Kennedys Creek Solar Farm

Surface Water Assessment

Client: 433 Link Development Pty Ltd

**Floodplain Management Advice for
Proposed Solar Farm
Lot 4, Plan PS318659
226 Murray Road Benalla Vic 3672**

Figure 7 GMW Map illustrating the confirmed waterway on the Kennedys Creek site (shown blue).

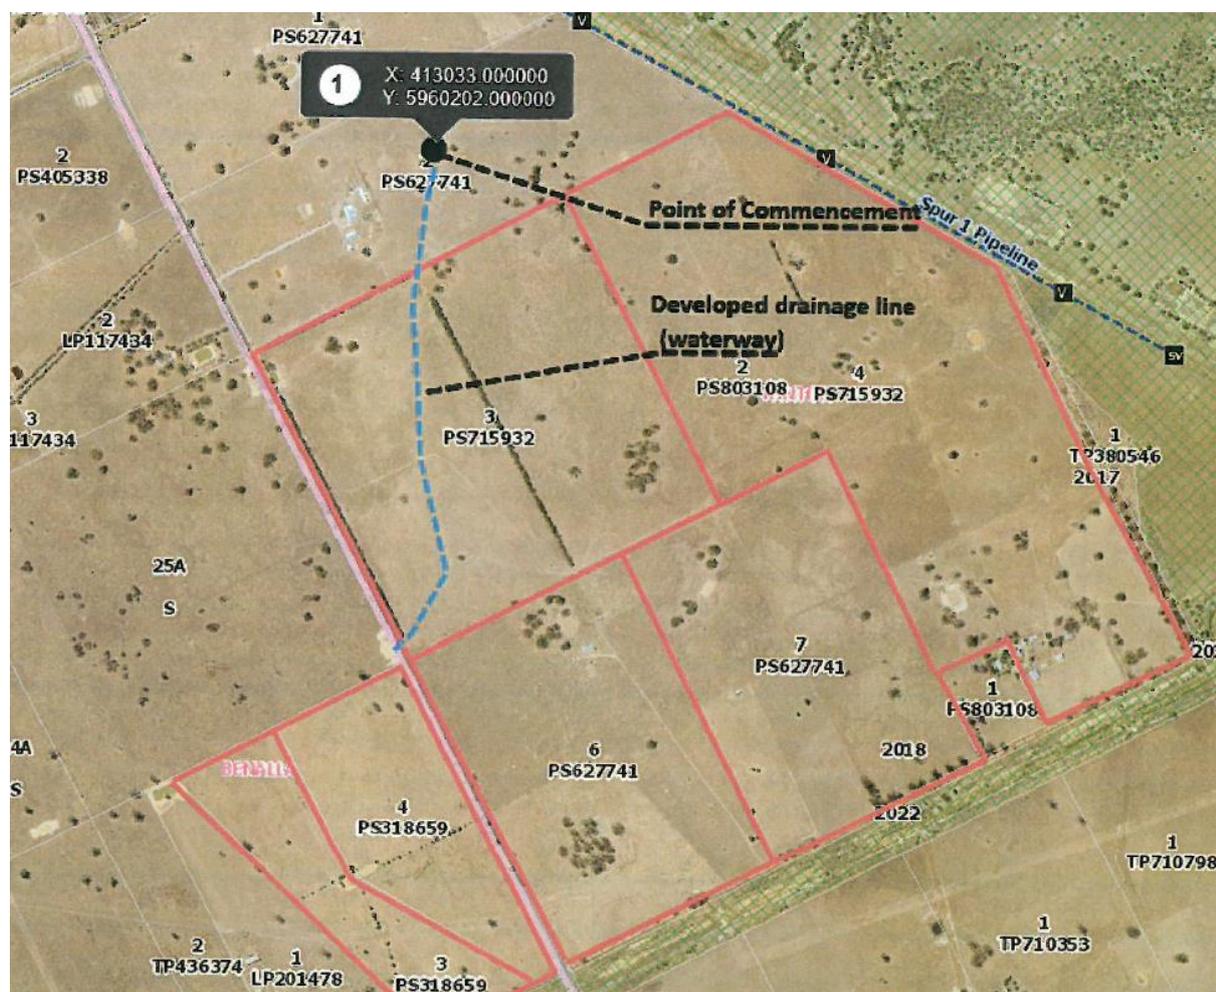
The waterway determination for the Kennedys Creek site identified one designated waterway within the study area. This waterway is located on the north-western section of the site and flows north across a number of land titles. Figure 7 illustrates the location of the waterway. The full map extent is presented in Appendix E. Section 3.2 of this report summarises how the outcomes from the GMW engagement were incorporated into the project.

Figure 1: Showing estimated 1% AEP flood contours and designated waterways.

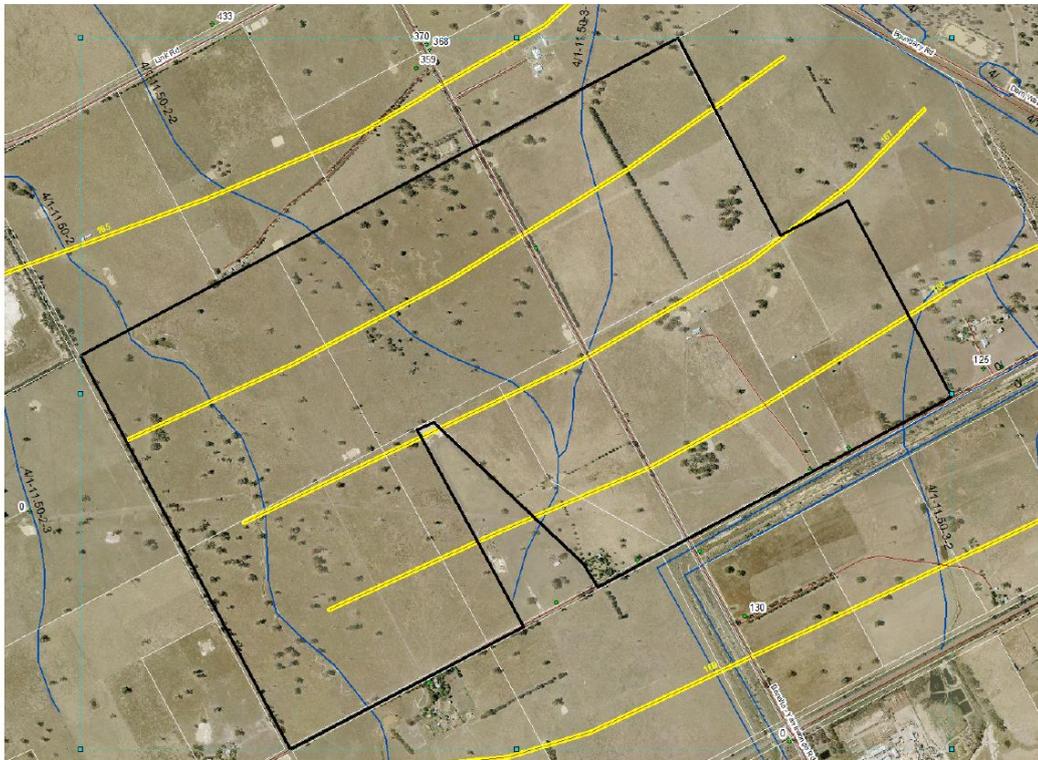
The Authority's best estimate of the 1% AEP flood levels for the location described above varies from 165.5 and 168.5 metres AHD (see Figure 1), which was established from limited 1993 flood levels. The Authority has no detailed ground level information to determine depths of flooding over the site.

Figure 1 also shows a number of designated waterways that traverse through the site. In this regard, the waterways should remain free from obstruction with vegetated corridors.

In the light of the above information, the Goulburn Broken CMA would not object to the proposed solar farm, **subject to the following conditions**:

1. Inverter and transformer blocks, any buildings, infrastructure and solar panels must be located a minimum of 30 metres from the nearest top of bank of the waterway shown in Figure 1.
2. The finished floor levels of inverter and transformer blocks and any buildings are to be set at least 300 millimetres above the applicable 1% AEP flood level as shown in Figure 1.

3. The corridors along all waterways, as shown in Figure 1, shall be revegetated in accordance with the Revegetation Guide for the Goulburn Broken Catchment (<https://revegetation.gbcma.vic.gov.au/>).
4. Where fencing crosses waterways, as shown in Figure 1, the fencing shall be designed such that it does not obstruct flood flows. For example, farm type fencing, large open mesh (150 mm centres), vertical pool style fencing (150mm centres), fencing that lifts with the floodwater or similar.

Note, where access roads cross the waterway shown in Figure 1 a works on waterways permit will be required from the Goulburn Broken CMA.
